Access Compliance Report

Public Rights-of-Way

Intersection ID: 29188	Main Street: JADE_GLEN_DR	Cross Street: SOUTHERN_SUGAR_DR	Location: SW
ADA ID: 7B9646DC1F7B	Ramp Type: PerpDiag	Initial Pass/Fail: Fail	Overall Compliance: No
		Severity Score: 10

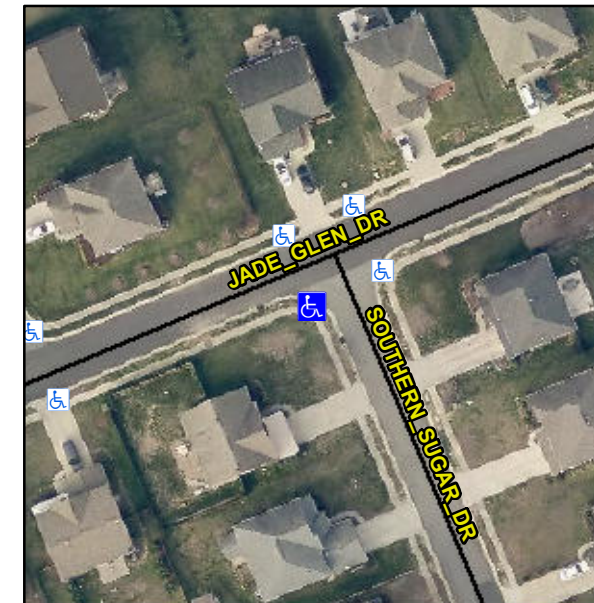
Not Found, R304.5.1, R304.5.3

Compliance	Description	Data	Compliance	Description	Data
N/A	Ramp Length (in)	46.0	Yes	Ramp Slope (%)	7.0
No	Ramp Width (in)	47.0	No	Ramp XSlope (%)	3.7
N/A	Flare Type LT	N/A	N/A	Flare Type RT	N/A
N/A	Flare Slope LT (%)	N/A	N/A	Flare Slope RT (%)	N/A
N/A	Flare Traversable LT?	N/A	N/A	Flare Traversable RT?	N/A
N/A	Landing Length (in)	N/A	N/A	DWS Provided?	N/A
N/A	Landing Width (in)	N/A	N/A	DWS Contrast?	N/A
N/A	Landing Slope (%)	N/A	N/A	DWS Length (in)	N/A
N/A	Landing X Slope (%)	N/A	N/A	DWS Full Width?	N/A
N/A	Landing Curb? (Y/N)	N/A	N/A	DWS Offset (in)	N/A
N/A	Shared Landing?	N/A			
N/A	Gutter Ponding?	N/A	N/A	Gutter Slope (%)	N/A
N/A	Gutter Lip Ht (in)	N/A	N/A	Gutter X Slope (%)	N/A
N/A	Painted X Walk1?	No	N/A	Painted X Walk2?	No
	X Walk 1 Direction	To N		X Walk 2 Direction	To E
N/A	X Walk 1 Width (in)	N/A	N/A	X Walk 2 Width (in)	N/A
	X Walk 1 Slope (%)	0.7		X Walk 2 Slope (%)	4.6
	X Walk 1 X Slope (%)	3.4		X Walk 2 X Slope (%)	0.1

Remove & Replace Curb Ramp With Two New Directional Ramps or Equivalent.
